City of Hamilton
Red Hill Valley Parkway Safety Review (DRAFT)
B000325 | July 2013
B000325

File path: P:\Project\Active\Transportation\B000325_Hamilton - Redhill Safety Study\080_REPORTS\B000325_RHVP_Safety_Review_Draft_Report_e00v01.docx

Figure 2 - Road Elements Included in the Study Area

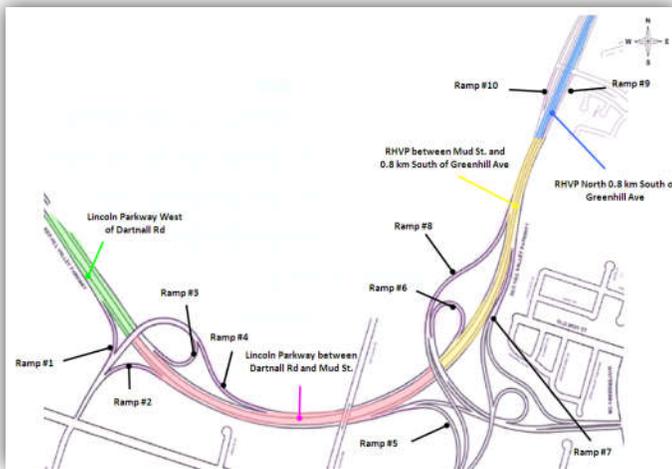
Commented [N8]: For clarity, this should be a bigger image, perhaps with the table merged into it

Figure 3 - Collision Bar Diagrams – Severity

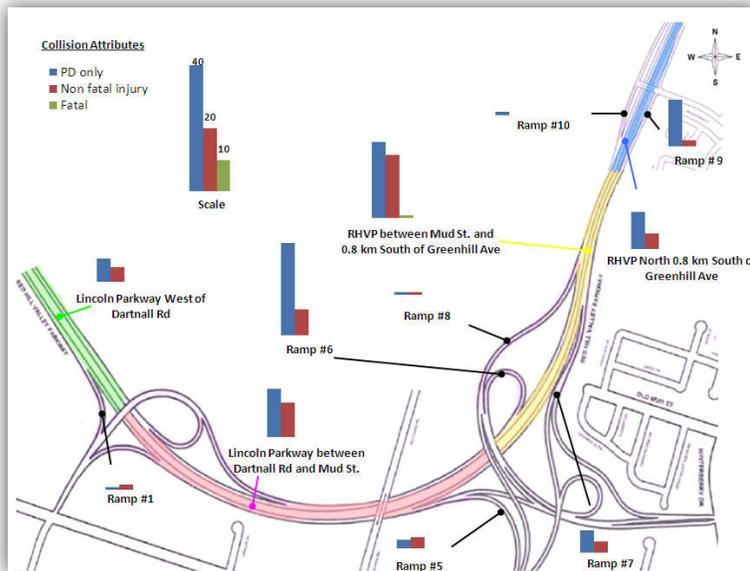
Commented [N11]: We should have collision numbers for each bar.

Commented [N12]: Agree. The "Scale" immediately indicated to me that there were 10 fatalities. Drop the scale and use #'s on each bar.

Figure 4 - Collision Bar Diagram - Impact Type

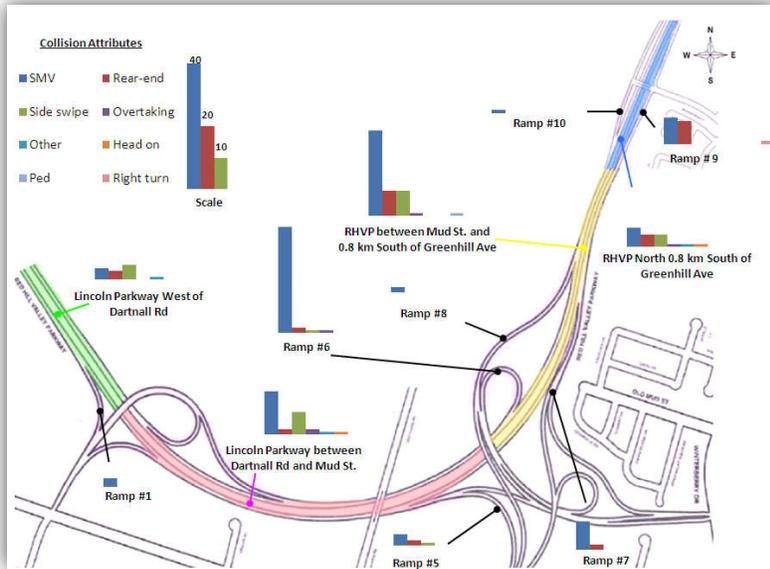
Commented [N13]: NO, this is proportion of non-fatal per section, is it not? So these figures are useful.

Figure 5 - Collision Bar Diagram – Lighting

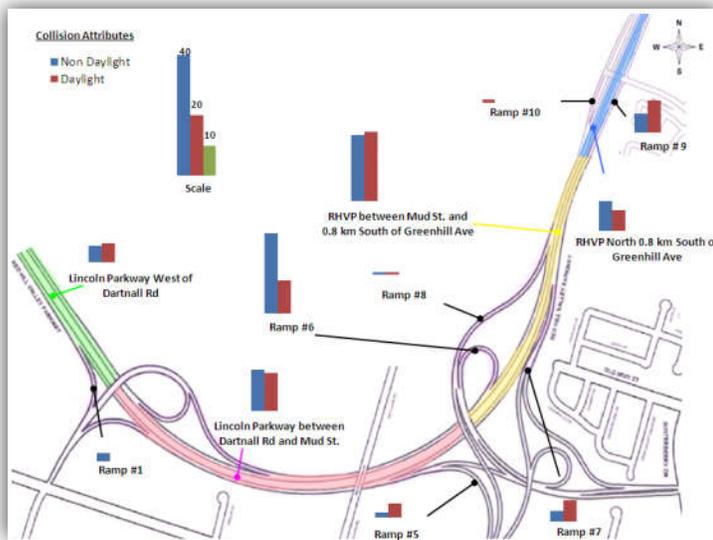
Commented [N18]: The same comment as above.

Figure 7 - Segmentation for the ISATe Tool

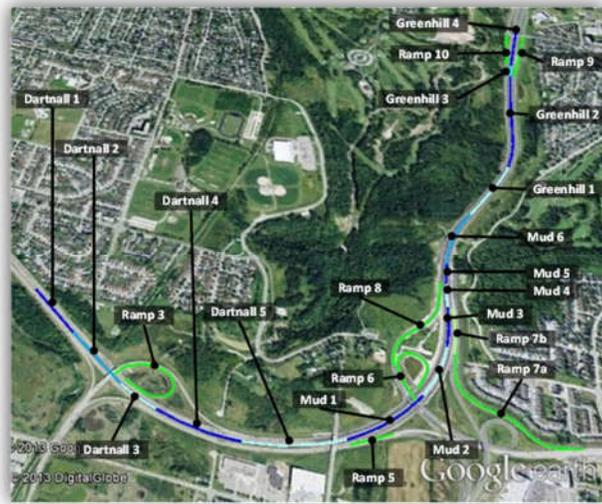
Commented [N24]: It seems this does not match the segmentation that was reported for our collision analysis. Why? Shouldn't our collision analysis be based on homogenous sections?

Figure 8 - Results of Operational Analysis for AM and PM Peak Periods

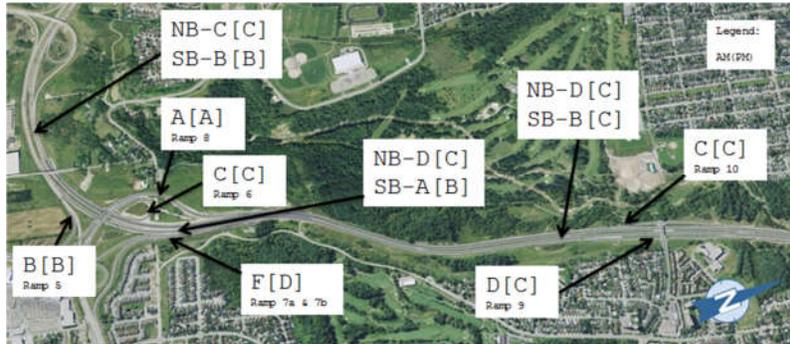
Commented [N40]: It seems you have F(D) for Ramp 7a and 7b. Ramp 9 is performing at D. What is the explanation for this?

Commented [N41]: Which one is AM? Which one is PM? Need a foot note
